APPLICATION NO.	FILING DATE	FIRST NAMED INVENTOR	ATTORNEY DOCKET NO.	CONFIRMATION NO.
10/591,320	06/02/2007	Akira Tsuboi	107348-00603	9440
4372 7590 09/29/2009 ARENT FOX LLP 1050 CONNECTICUT AVENUE, N.W. SUITE 400 WASHINGTON, DC 20036			EXAMINER DODD, RYAN P	
			ART UNIT 3655	PAPER NUMBER
			NOTIFICATION DATE 09/29/2009	DELIVERY MODE ELECTRONIC

Office Action Summary	Application No.	Applicant(s)	
	10/591,320	TSUBOI ET AL.	
	Examiner	Art Unit	
	RYAN DODD	3655

DETAILED ACTION

Fig. 1

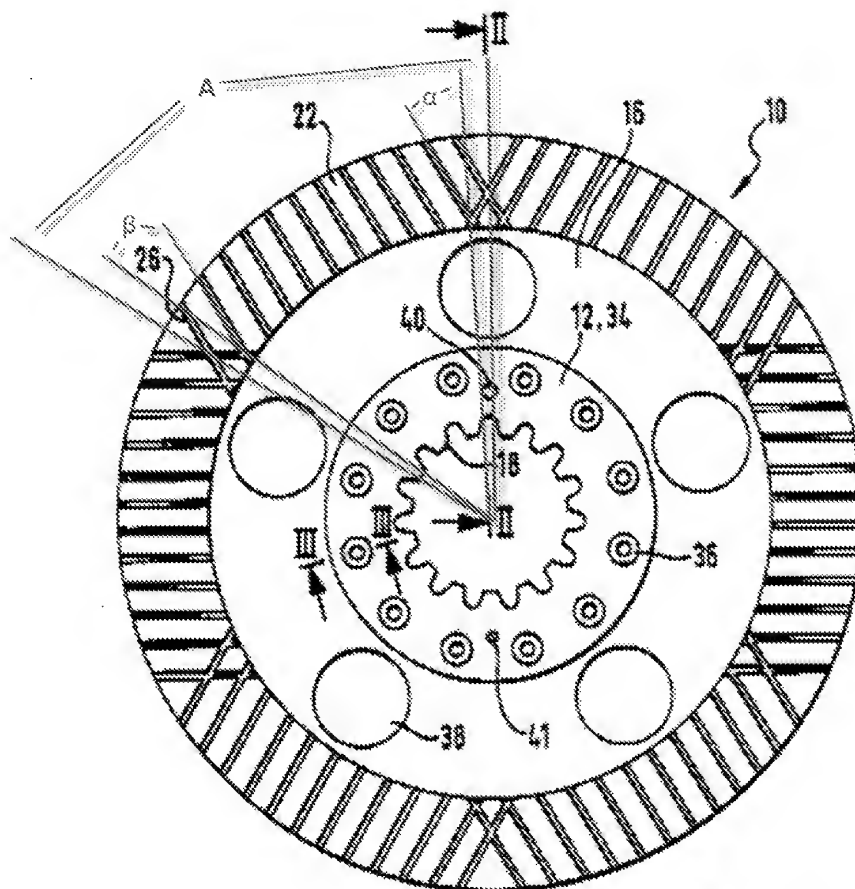
Claims 1 and 2, as best understood, are rejected under 35 U.S.C. 102(b) as being anticipated by Vogele 4967893 (henceforth Vogele '893). Vogele '893 discloses a wet clutch friction plate comprising a core plate (support plate) and a friction material (friction lining 22) bonded to a side face of the core plate, a plurality of oil channels (grooves 26) being formed in the friction material so as to provide communication

between inner and outer peripheral edges of the friction material (21), characterized in that a plurality of oil channels having a discharge angle (β) that discharge oil from an inner peripheral side to an outer peripheral side of the friction plate (15) when the friction plate rotates and a plurality of oil channels having an inflow angle (α) that draw oil in from the outer peripheral side to the inner peripheral side of the friction plate (15) are mixed at substantially equal intervals (See figure below).

Vogele '893 likewise discloses that the friction plate is divided into a plurality of regions (A) arranged in the peripheral direction, a plurality of oil channels parallel to each other are formed in the friction material of each region (A), and one oil channel

and another oil channel (22) that are positioned at opposite end parts in the peripheral direction of each region (A) are given the discharge angle (β) and the inflow angle (α) respectively.
